# BRAIDWOOD STATION, UNIT NO. 1

## AMENDMENT TO FACILITY OPERATING LICENSE

Amendment No. 95 License No. NPF-72

# ATTACHMENT TO LICENSE AMENDMENT NOS. 95 AND 95

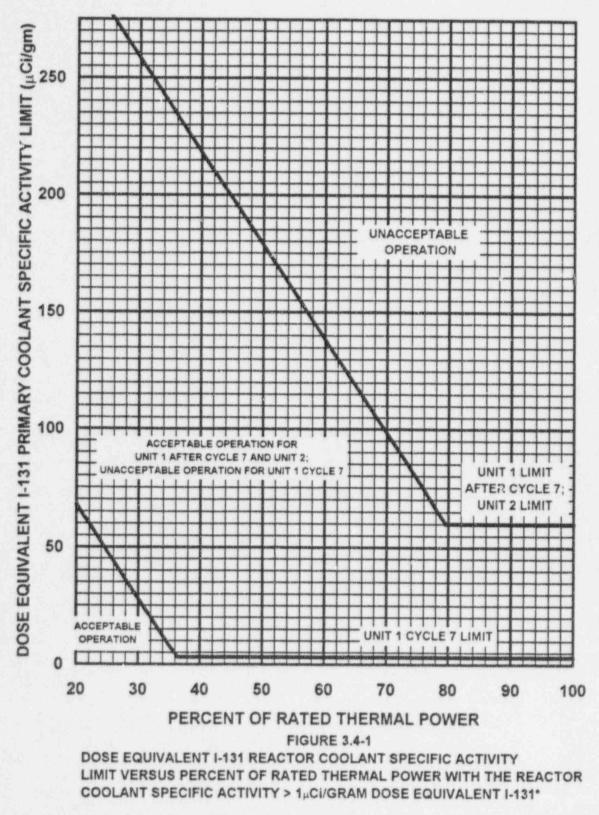
With the specific activity of the reactor coolant greater than 1 microCurie per gram DOSE EQUIVALENT I-131\* or greater than 100/E microCuries per gram, perform the sampling and analysis requirements of Item 4.a) of Table 4.4-4 until the specific activity of the reactor coolant is restored to within its limits.

\*For Unit 1 through Cycle 7, reactor coolant DOSE EQUIVALENT I-131 will be limited to 0.05 microCuries per gram

\* For Unit 1 through Cycle 7, Reactor Coolant Specific Activity > 0.05 µCi/Gram DOSE EQUIVALENT I-131.
